ISSUE: Permit to Demolish/Capsulate (partial) and Certificate of Appropriateness for alterations

APPLICANT: NK Washington Street LLC

LOCATION: Old and Historic Alexandria District
424 North Washington Street

BAR #2022-00126 and BAR #2022-00131
424 North Washington Street

Figure 1: Circled walls are to be removed, as are the door and sidelights at the top of the image.

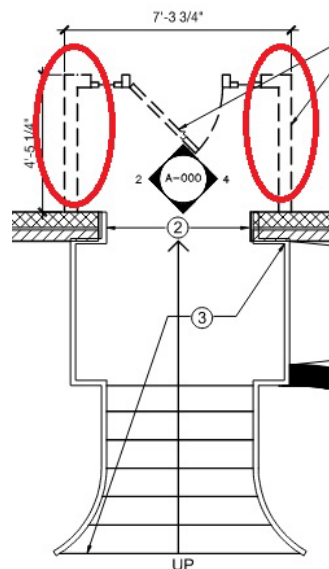
The applicant proposes demolishing approximately 90 square feet of masonry at the first-floor southernmost vestibule entrance to the building. Each wall is 4'5 1/4" wide by approximately 10' high. See Figure 1. The existing door and sidelights will also be removed but the transom glass and framing will be saved for relocation.

The analysis of the standards indicated above relate only to the specific portions of the building proposed for demolition/capsulation, not the overall building. In the opinion of staff, none of the criteria for demolition and capsulation are met and the Permit to Demolish/Capsulate should be granted. The select portions of the building proposed for demolition are not themselves of unusual or uncommon design on this 1978 building. Staff therefore supports the Permit to Demolish.
